COLUMBIANA HI TECH LLC

Subject: Application for revision of Certificate of Compliance No. 9291 for the Model No. Liqui-Rad (LR) Transportation Unit Package, Docket No. 71-9291

The following list summarizes the changes to the Safety Analysis Report for Revision 9 for Certificate of Compliance No. 9291 for the Model No. Liqui-Rad (LR) Transportation Unit Package, Docket No. 71-9291.

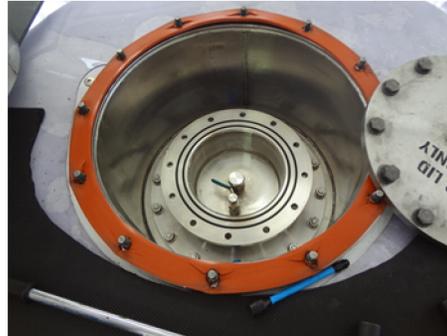
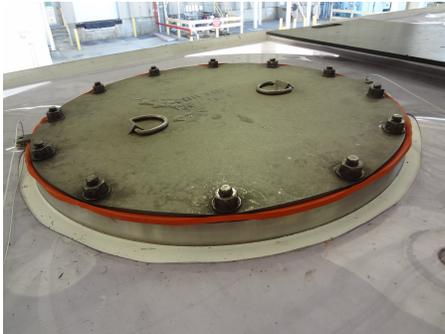
The operating procedures provide in Chapter 7 of the LIQUI-RAD Safety Analysis Report, specify torque values of 75 [+10 -0] ft. lbs. for the primary lid, secondary lid, and out lid fasteners. The primary lid is a 5/8 inch thick flange that is bolted to the containment vessel and secondary lid is 3/4 inch thick plate that bolts to a 3/4 inch thick flange on the primary lid. Both the primary and secondary lids are thick metal lids that are designed to withstand design pressures and compress o-rings to provide containment boundary closure seals. The intent of torquing the closure bolts/studs is to provide a preload force that ensures the seals maintain leak tightness during routine, normal, and accident transport conditions. The outer lid is a 1/4 thick steel plate with material for thermal and impact protection on the inside surface. There is also an optional manual vent enclosure (MVE) that houses a valve for venting any pressure build up between the outer lid and space outside the containment vessel. A flat rubber gasket provides an environmental seal between the outer lid and space that provides access to the containment vessel secondary and primary lids. The intent of the closure bolts on the outer lid is only to retain the outer lid that provides protection of the confinement boundary from condition incident to transport, including normal and accident conditions. The outer lid seal prevents ingress of water and dust incident to routine transport conditions.

Torquing the outer lid fasteners to 75 ft.-lbs., as specified in the Chapter 7 – Operating Procedures, results in damage to the flat rubber gasket and deformation of the metal flange on the outer lid as shown in photographs below. The outer lid fasteners only need be tightened enough to compress the flat rubber gasket to provide environmental seal and prevent the fasteners from loosening from vibration during routine transport conditions. Tests have been performed to demonstrate that a torque of 30 [+10 -0] ft.-lbs. applied to the outer lid stud nuts

results is sufficient to compress the environmental seal and ensure the fasteners will not loosen when subject to conditions incident to routine transport.

A change to the Chapter 7- Operating Procedures is proposed that will prevent damage to the outer lid flange and gasket while providing sufficient clamping force to meet the design criteria. The outer lid placed over the bolting studs installed in a flange on the outer packaging shell, and secured using a washer and hex nut. The out lid fasteners are tightened using a recommended sequence and checking the final tightening ensure uniform compression of the gasket. The recommendations for tightening are also proposed for the secondary lid closure installation.

Note 11 on the engineering drawing for package approval, LIQUI-RAD TRANSPORT UNIT, Sheet 4 of 4 (LR-SAR Revision 10), General Notes, is revised to specify a torque value of 75 ft. lbs. for the primary lid and secondary lid that are part of the containment boundary. The outer lid nuts torque is specified as 30 ft. lbs. to ensure securement for shipping and prevent damage to the outer lid flange.
